Relevant Information for Local Planning Panel

SUBJECT: Information Relevant To Item 3 – Development Application: 21C Billyard Avenue, Elizabeth Bay – D/2023/727

**SUPPLEMENTARY JOINT EXPERT REPORT ADDRESSING HEIGHT OF BUILDINGS
CALCULATION**

Supplementary Joint Expert Report
Appendix B: Height Plane Amendment

DWG NO
DA450

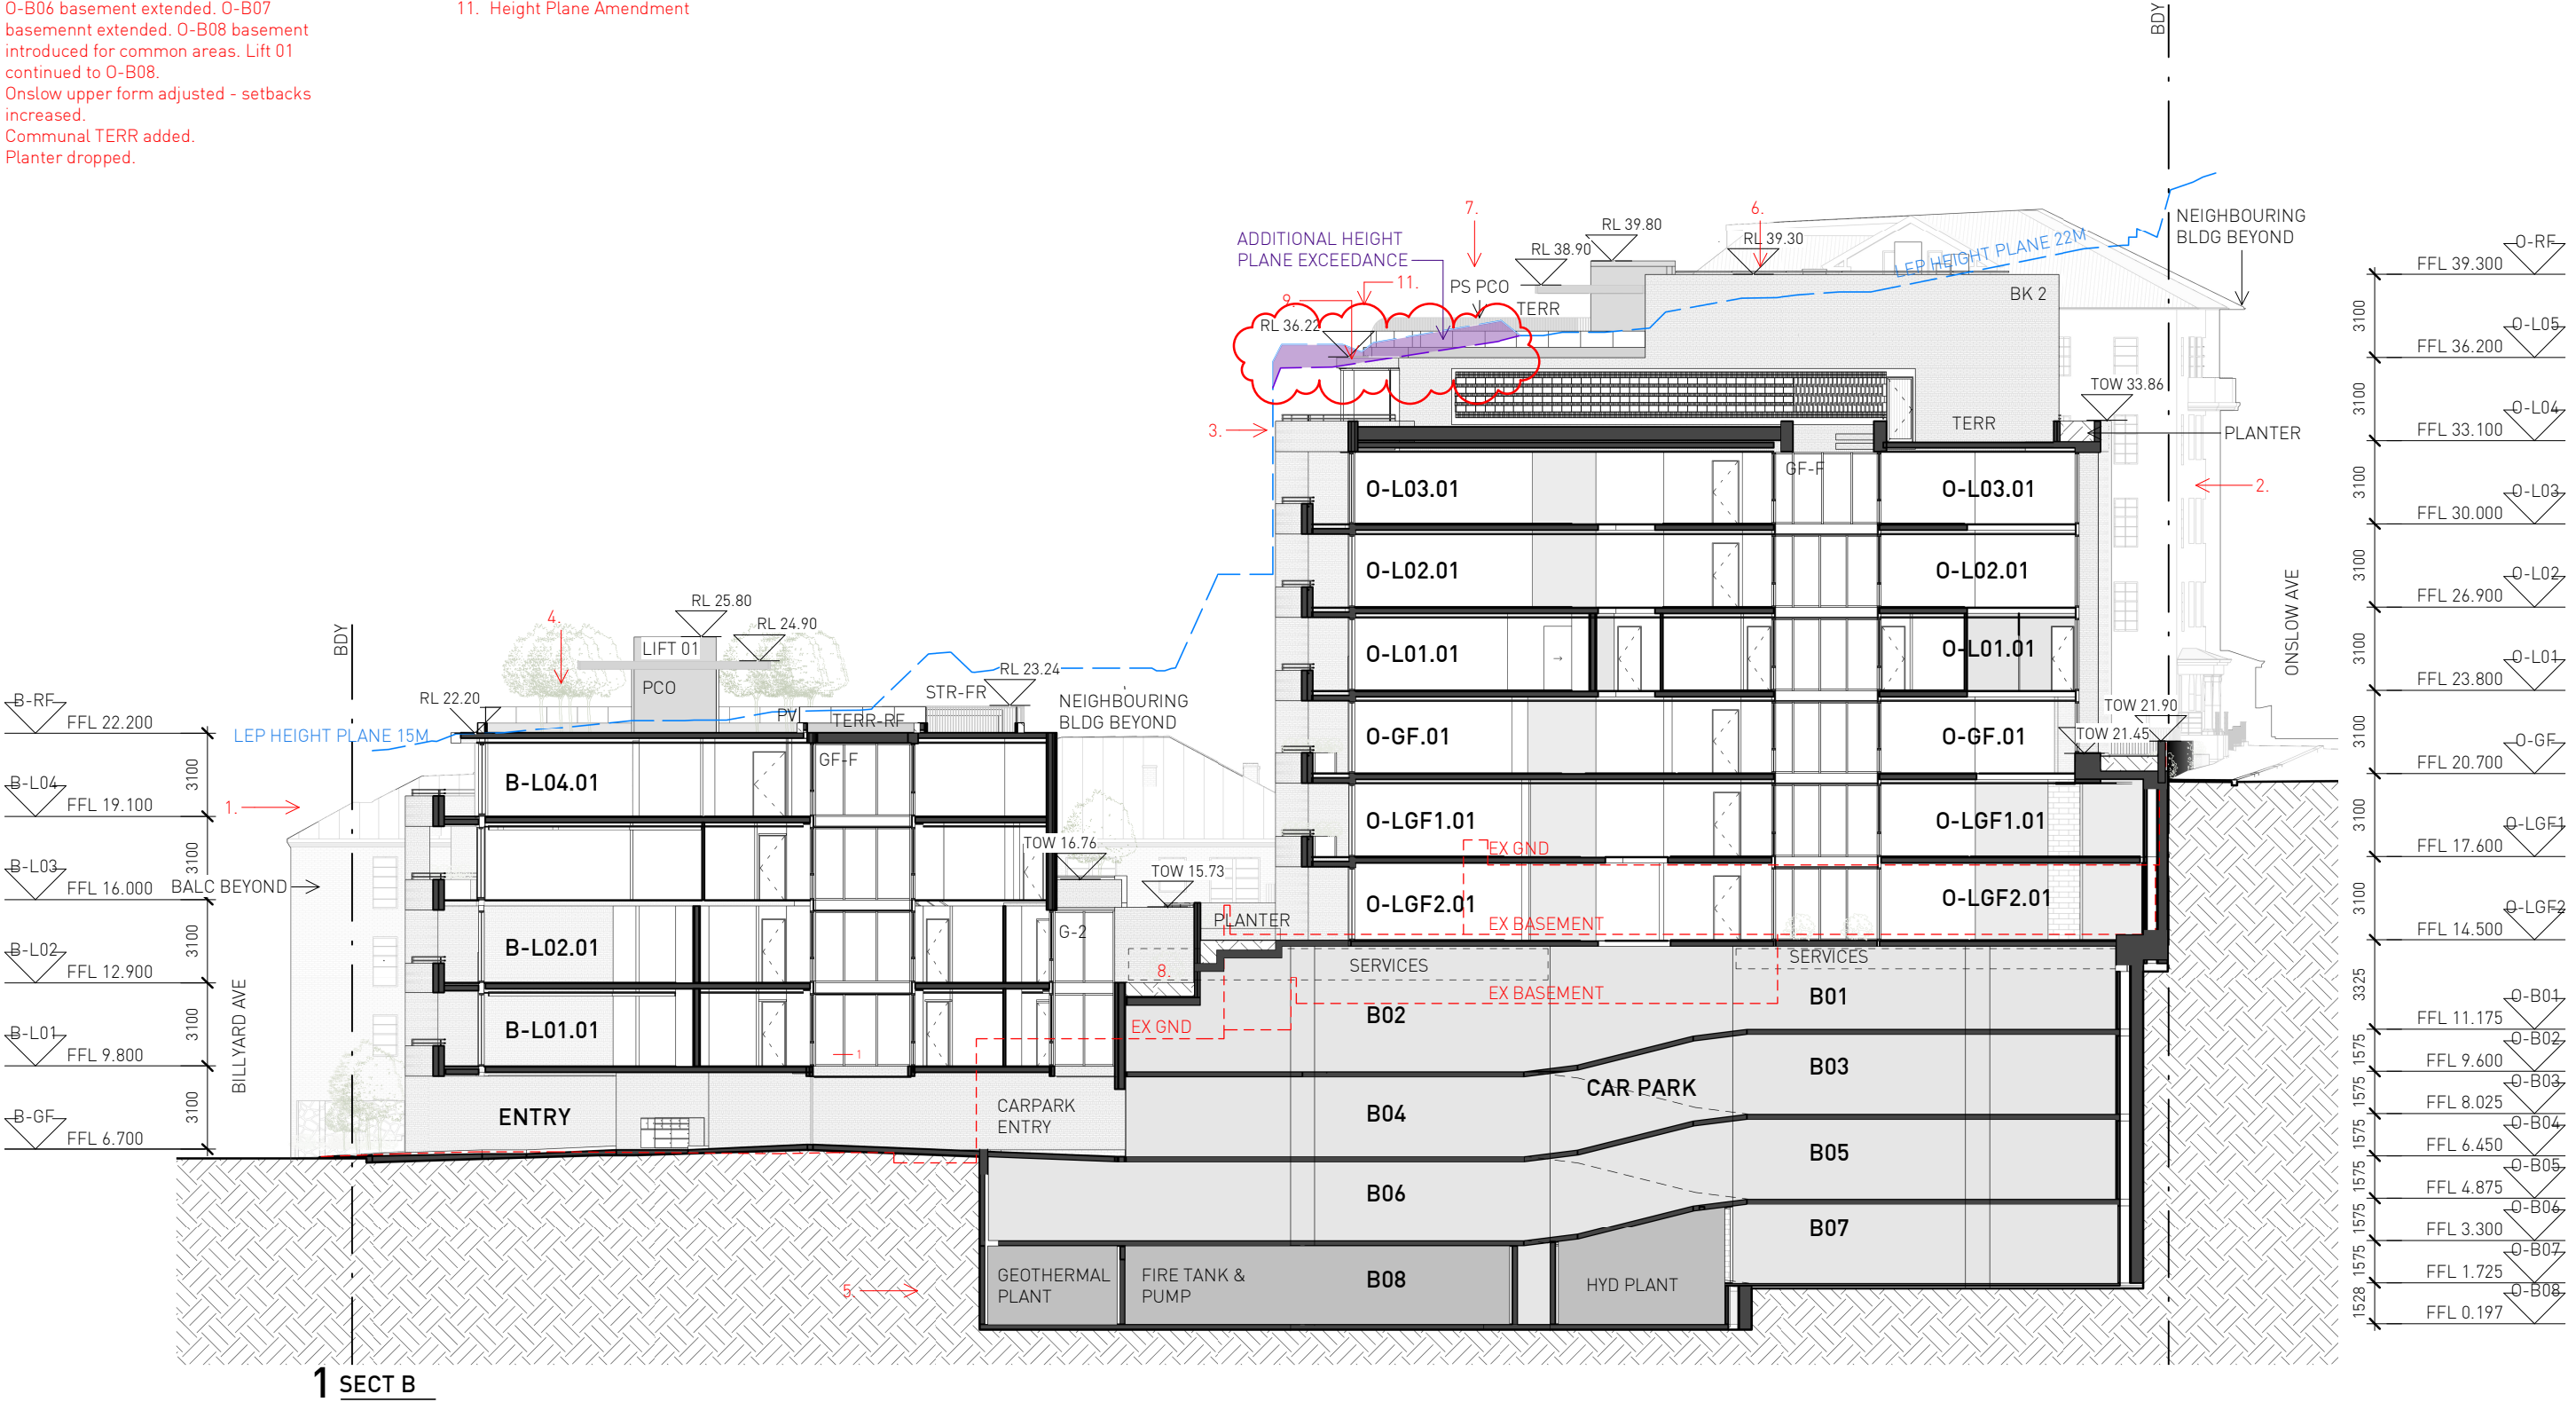
- 1. Billyard street setback increased by 1m.
- 2. Onslow street setback increased by 1.8m.
- 3. Height Plane & demarcation line adjusted.
- 4. Billyard Rooftop area allocated to communal open space. Private Penthouse Terrace removed.
- 5. O-B06 basement extended. O-B07 basement extended. O-B08 basement introduced for common areas. Lift 01 continued to O-B08.
- 6. Onslow upper form adjusted - setbacks increased.
- 7. Communal TERR added.
- 8. Planter dropped.

- DA ISSUE 07:
- 9. Onslow Penthouse splayed and curved for solar compliance to 12 Onslow.
- DA ISSUE 09:
- 10. Detailing of walls & facade elements shown.
- DA ISSUE 09A:
- 11. Height Plane Amendment

1 SECTION H

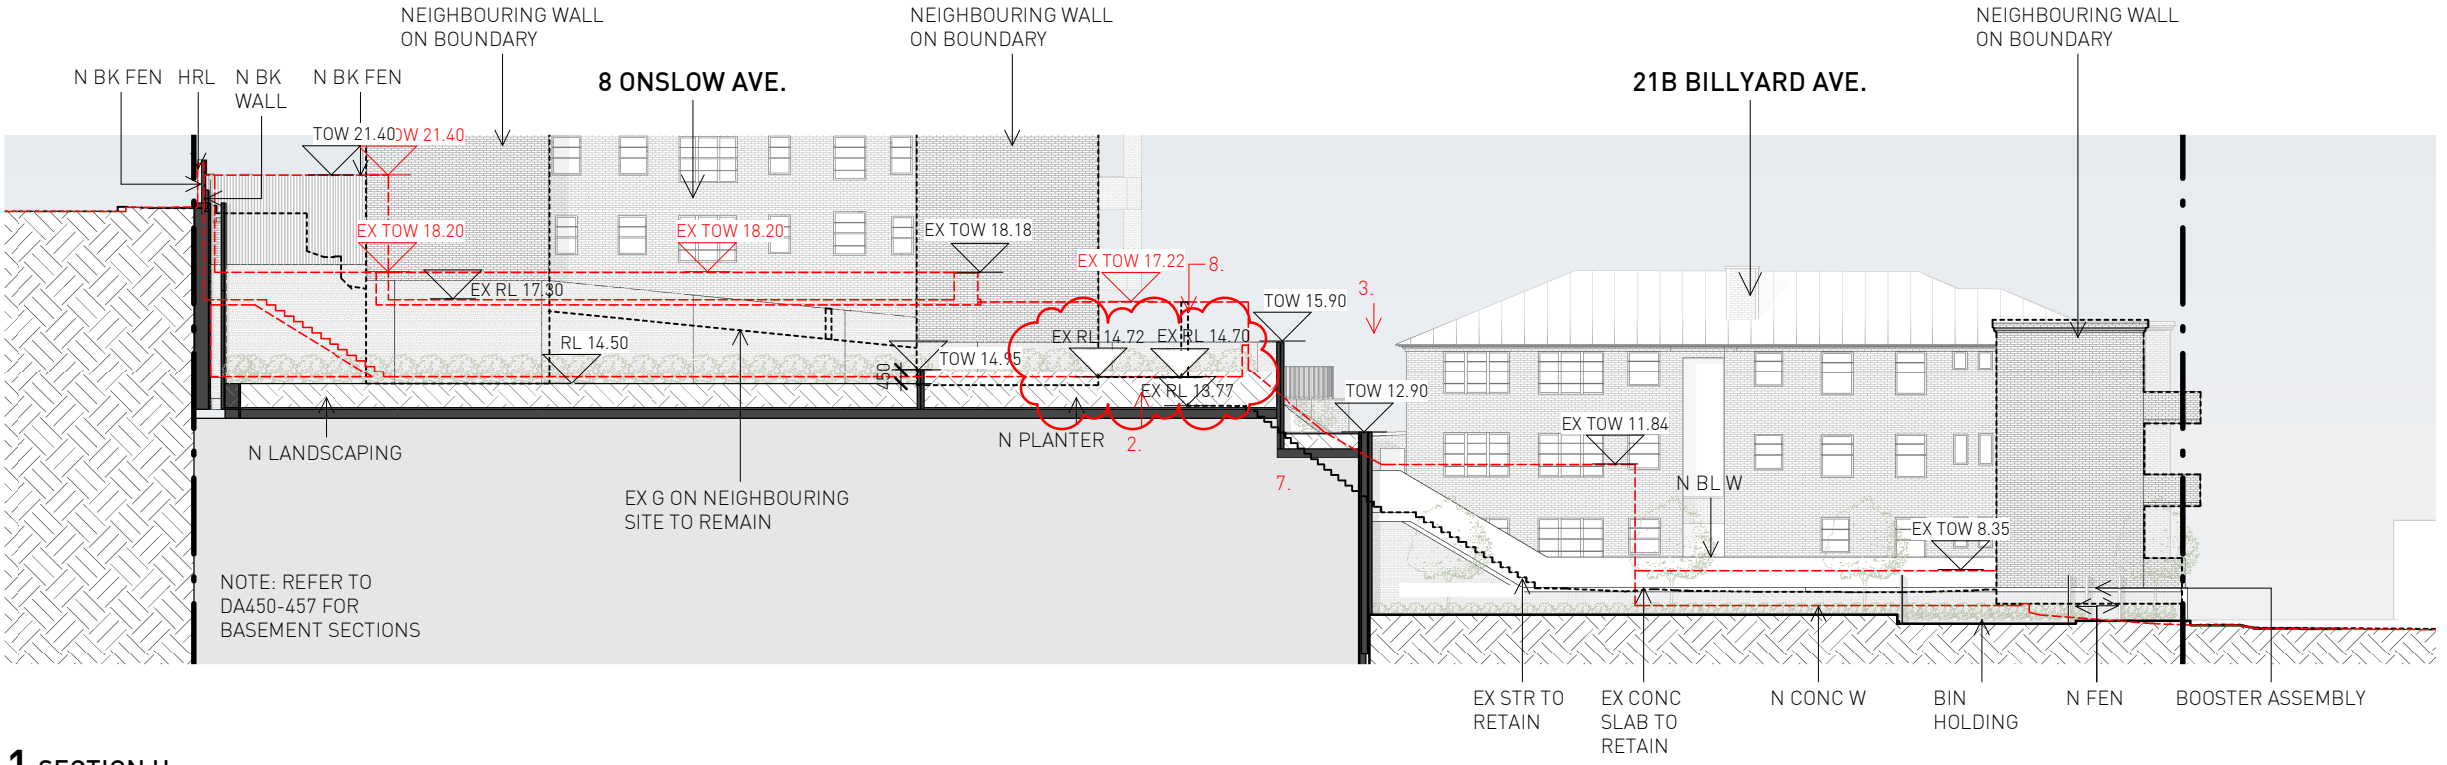
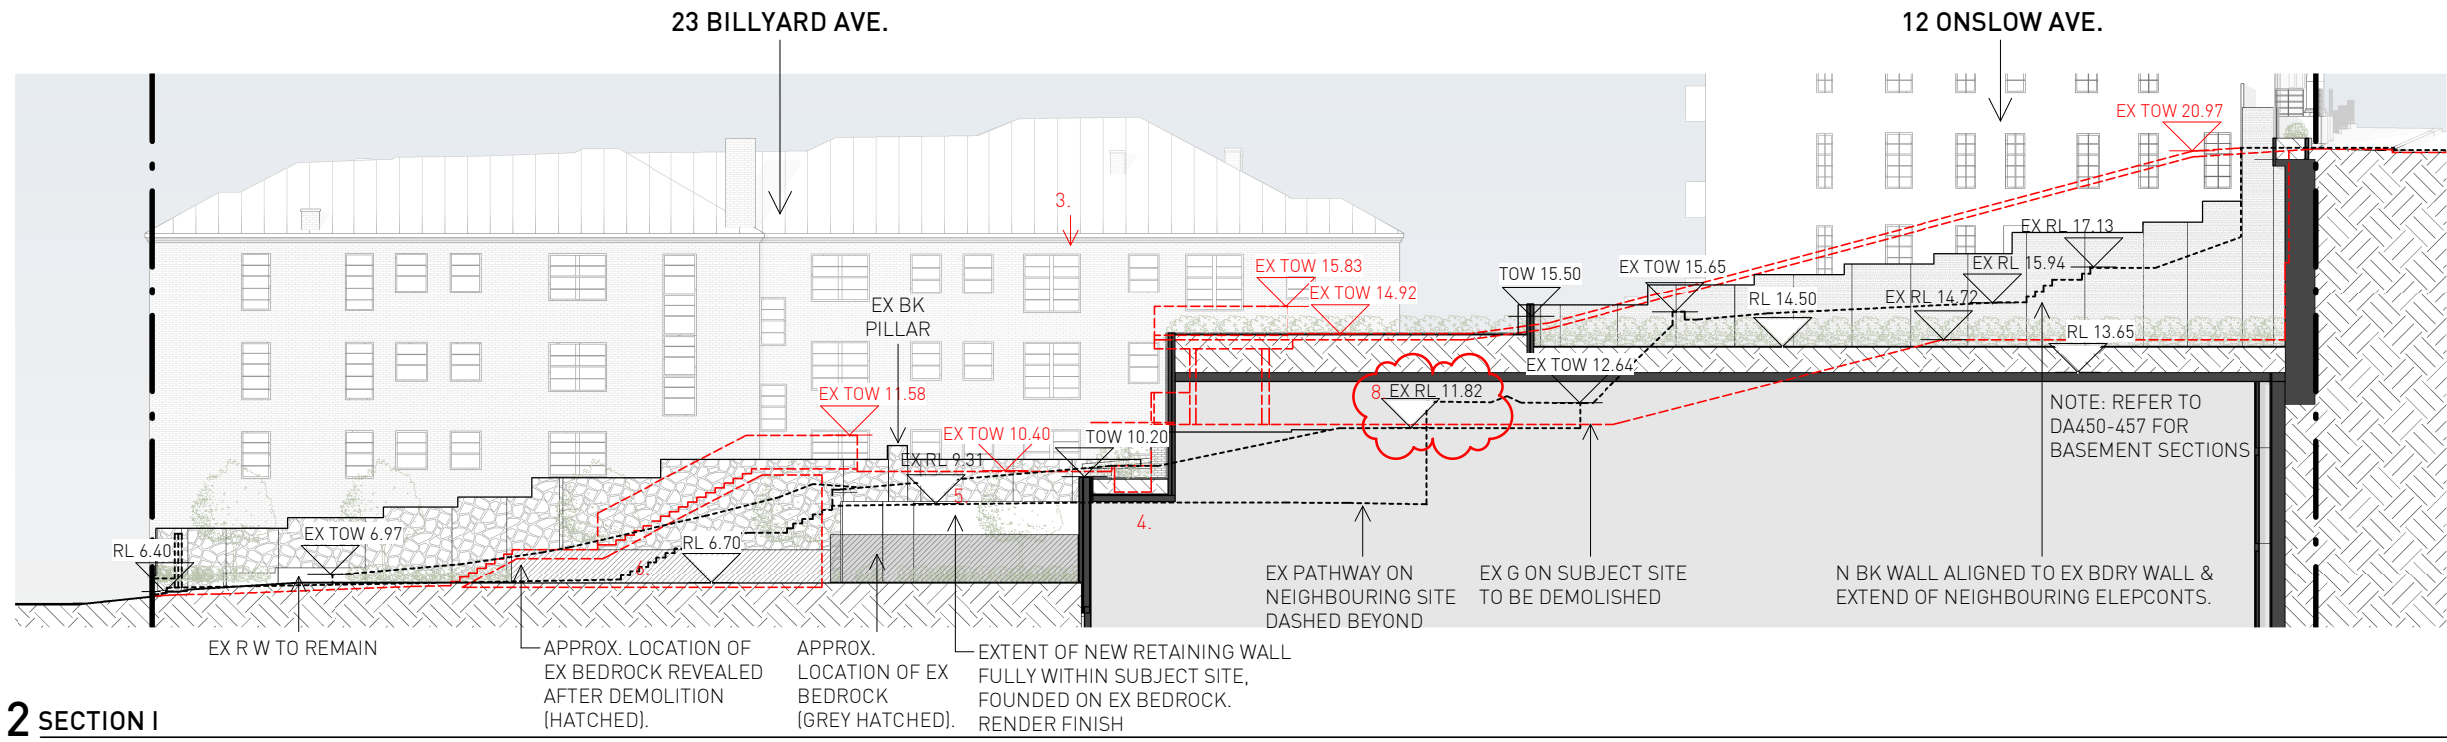
1. New drawings added.
2. 8 Onslow Courtyard level updated.
3. Planters level dropped.

DA ISSUE 07:
4. Planter dropped.

DA ISSUE 08:
5. New retaining wall added and deep soil adjusted.
6. Further description of bedrock provided.

DA ISSUE 09:
7. Graphical error corrected.

DA ISSUE 09A:
8. Existing RLs amended.
